# ABINGTON TOWNSHIP

## PLANNING COMMISSION MEETING

- a. Review the Preliminary/Final Major Subdivision and Land Development for LD-23-03 - 1583 Rothley Avenue.

**RE: Executive Summary for LD-23-03-1583 Rothley Avenue**  
**PARID: 30-00-60076-00-5/ TMID: 30200 002**  
**PARID: 30-00-60072-00-9/ TMID: 30200 003**  
**Preliminary/Final Major Subdivision & Land Development Plans Review (2<sup>nd</sup> Submission)**

**LAND DEVELOPMENT PLAN**  
**1583 ROTHLEY AVENUE**  
 PREPARED FOR  
**DOLSON, LLC**  
 ABINGTON TOWNSHIP, MONTGOMERY COUNTY, PA.

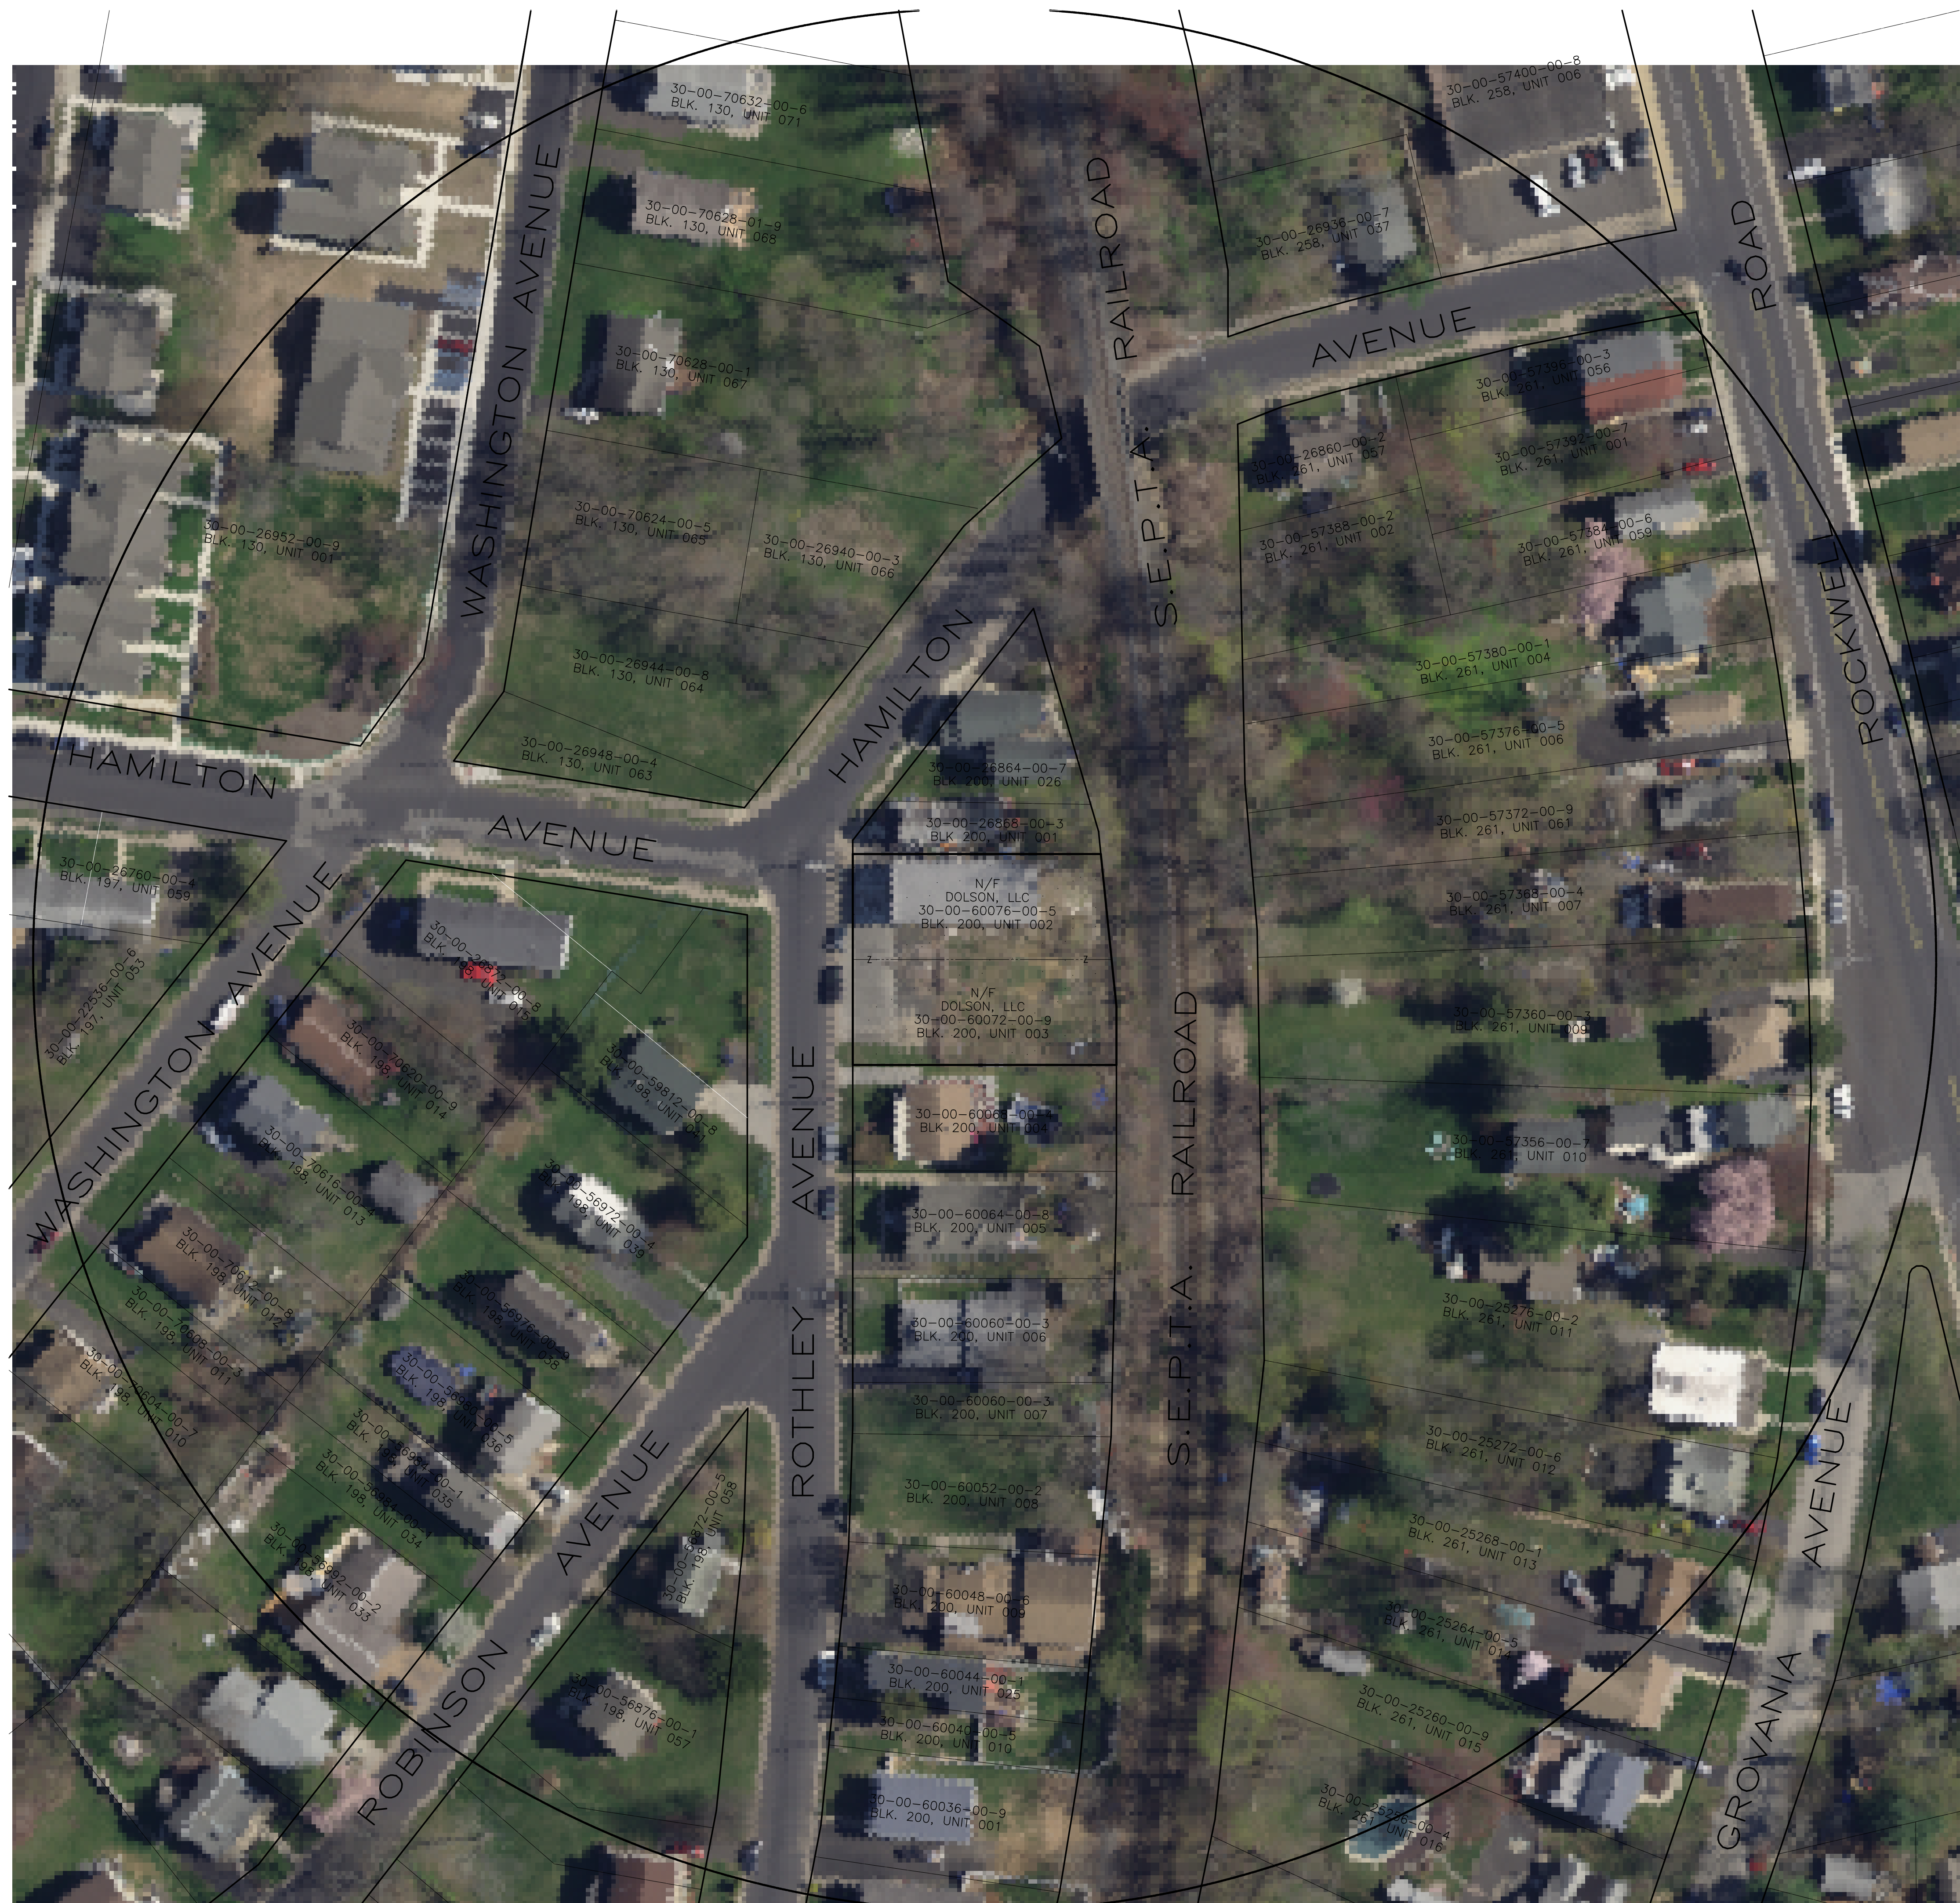
**A note has been provided on the Land Development Plan (Sheet 3) that a stormwater blanket easement is provided for this site. A description of this blanket easement shall be provided for review and approval.**

EXISTING RESOURCE AND SITE ANALYSIS MAP (ERSAM)  
EXISTING FEATURES / DEMOLITION PLAN  
1583 ROTHLEY AVENUE  
PREPARED FOR  
DOLSON, LLC  
ABINGTON TOWNSHIP, MONTGOMERY COUNTY, PA.

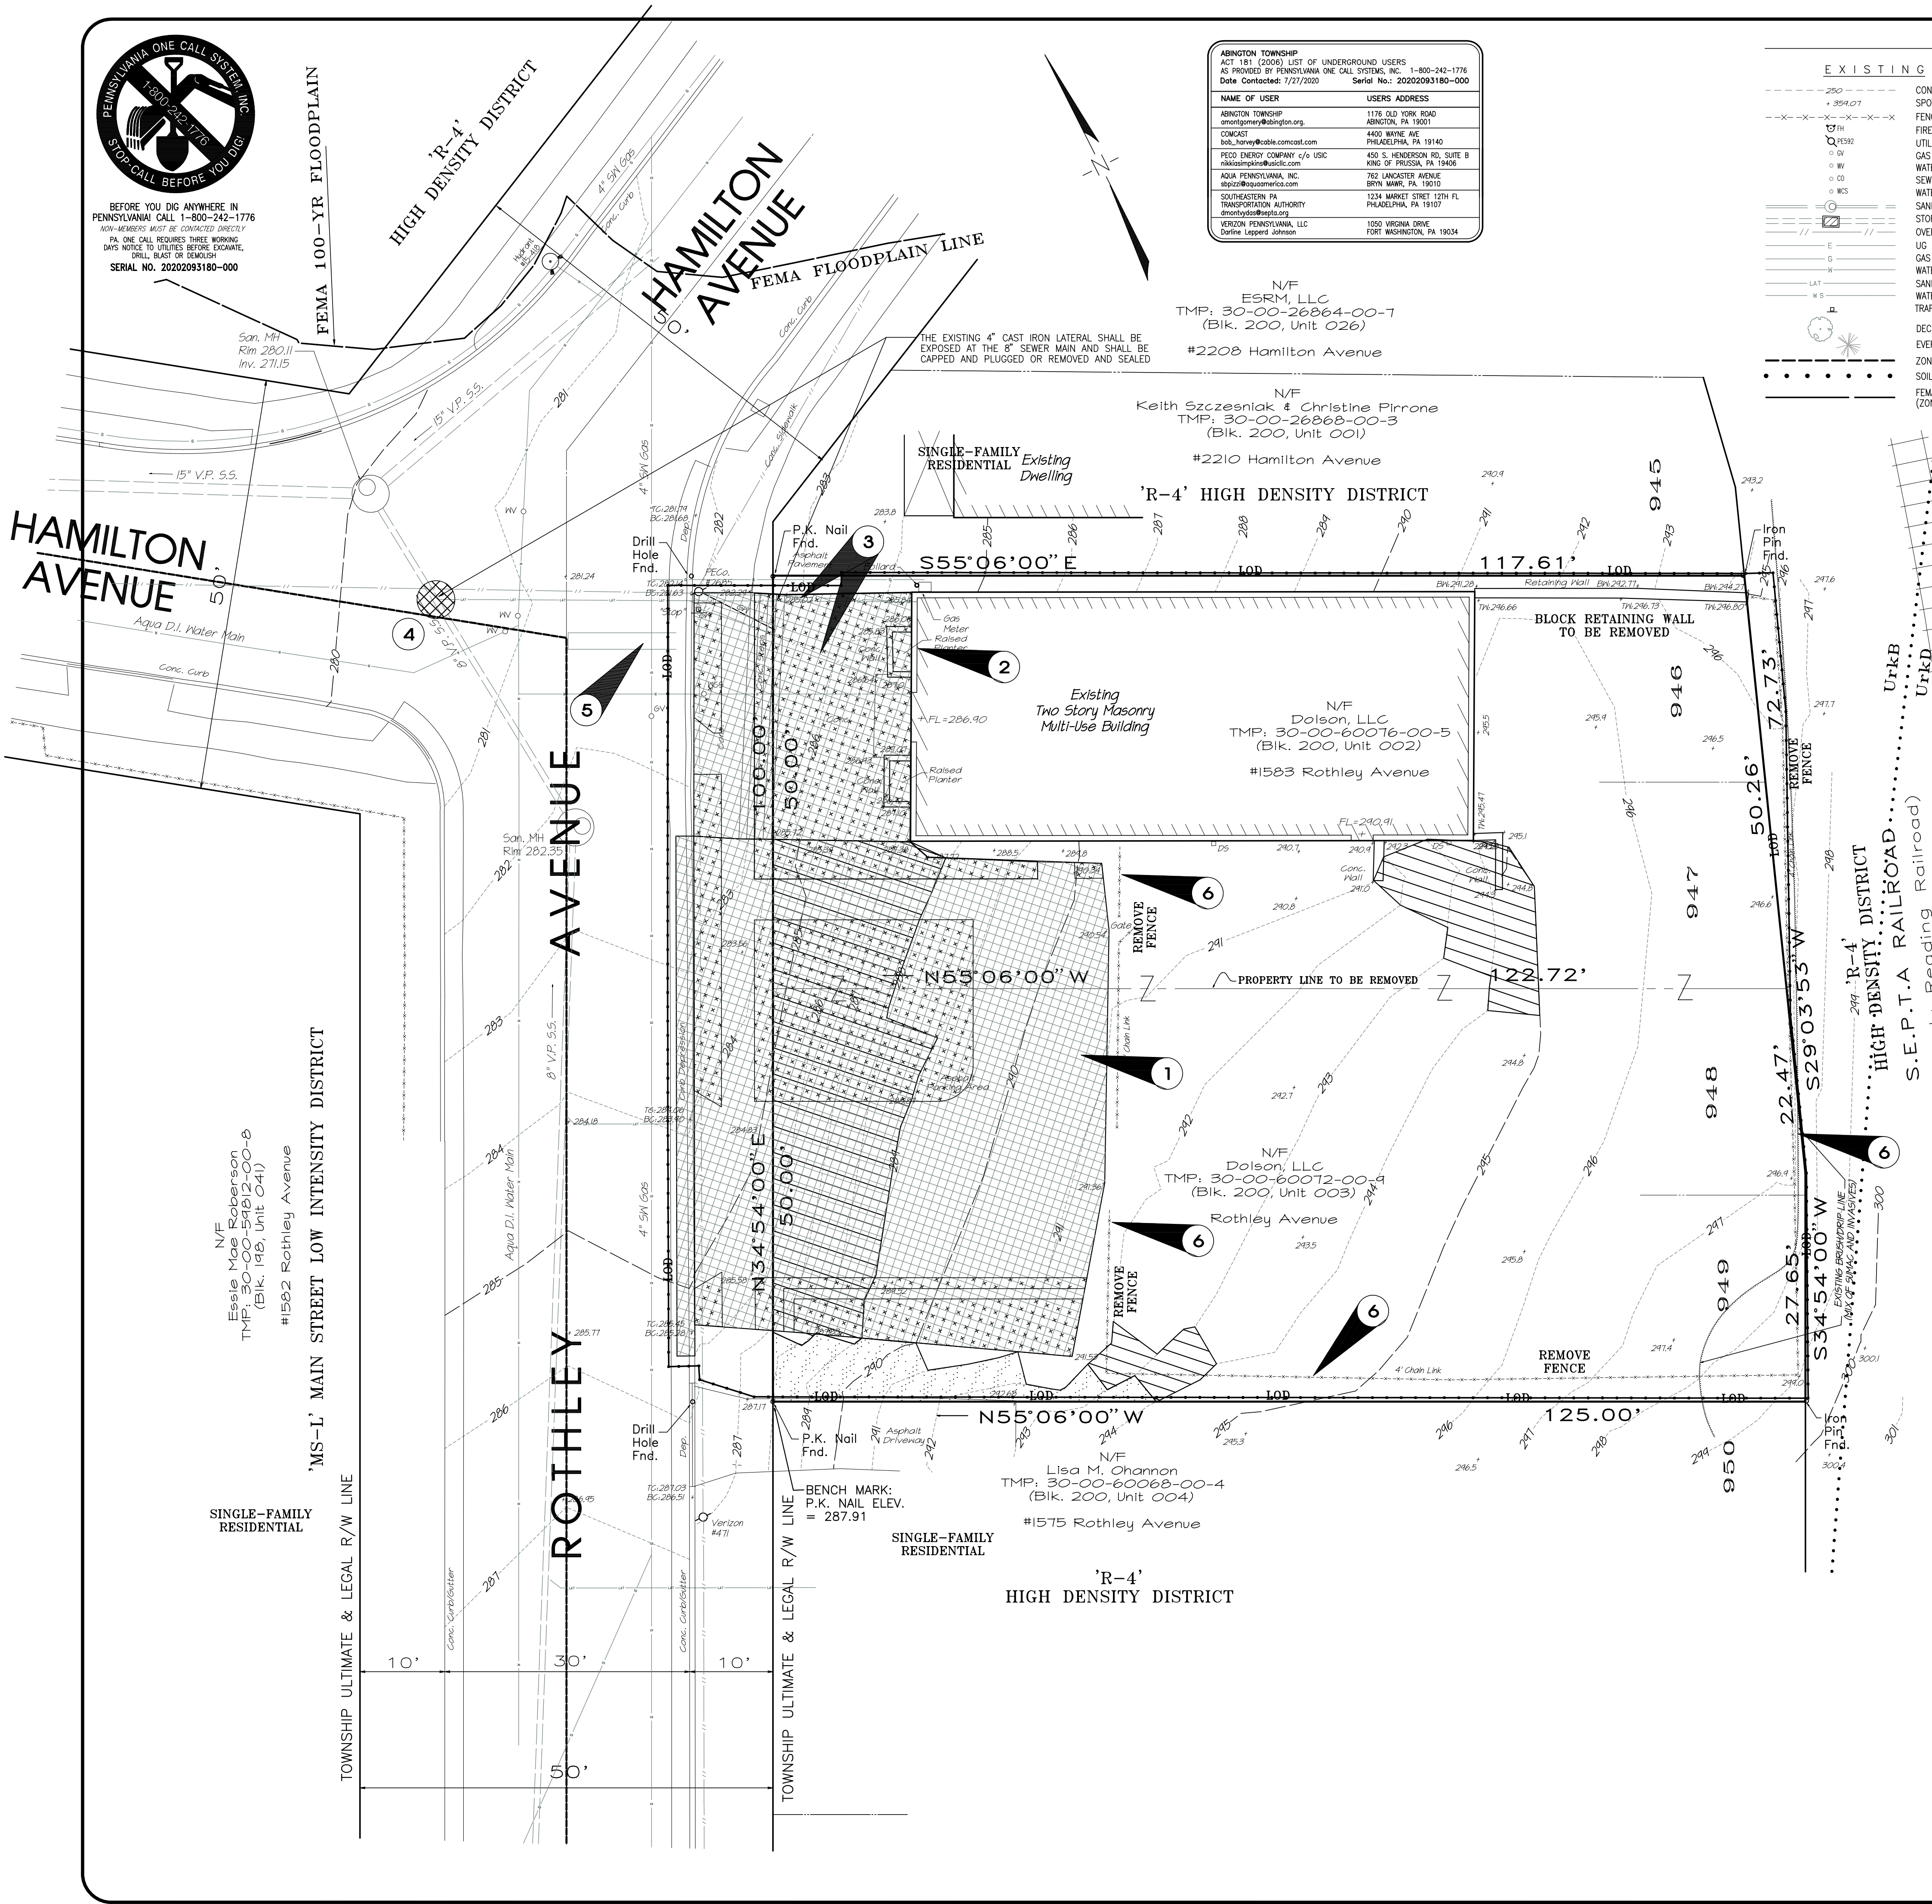
There are existing precautionary (slopes of 15% to 25%) and prohibited (slopes of 25% and up) steep slopes on the site based on our calculations of the topographic contours on the Existing Features/Demolition Plan (Sheet 5). However, these existing steep slopes on the site do not span five contiguous 10-foot contour intervals; and therefore, the site is not located within the steep slope conservation overlay district, and the site is not subject to the Steep Slope Conservation Overlay District requirements.

The developer is requesting a waiver from requirements in SLDO, Section 146-43.C (3) (a) related to cut and fill slopes – noting that some lawn areas exceed 15% slope. Any slopes exceeding 8% should have been shown on Sheet 5 and alternative site design should be considered that complies with township standards.

**The Applicant has provided the utility information within the site and along Rothley and Hamilton Avenues on the Existing Features/Demolition Plan (Sheet 5) but not within 400 feet of the subject property.**

**Based on an aerial view of the site, there are existing trees on the site along the rear property line adjacent the SEPTA rail tracks which are not shown on the Existing Features/Demolition Plan (Sheet 5). The Applicant has indicated in the Landscaping Plan (Sheet LP-2) that there are no qualifying trees present on the site. However, the Applicant shall include the existing trees and tree canopy on the Existing Features/Demolition Plan to accurately show the existing site conditions.**

**Based on an aerial view of the site, there are existing trees on the site along the rear property line adjacent the SEPTA rail tracks which are not shown on the Existing Features/Demolition Plan (Sheet 5). The Applicant shall include the existing trees and tree canopy on the Existing Features/Demolition Plan and clarify and label on the plans if these existing trees will remain or to be removed. In addition, the Applicant shall be required to provide temporary tree protection zones per this Code Section for any existing vegetation that are designated to remain.**

47. A portion of the existing asphalt driveway will be replaced by grass area in the proposed condition. The Existing Features/Demolition Plan (Sheet 5) shall call out the portion of the existing asphalt parking area that will be removed for the grass area.
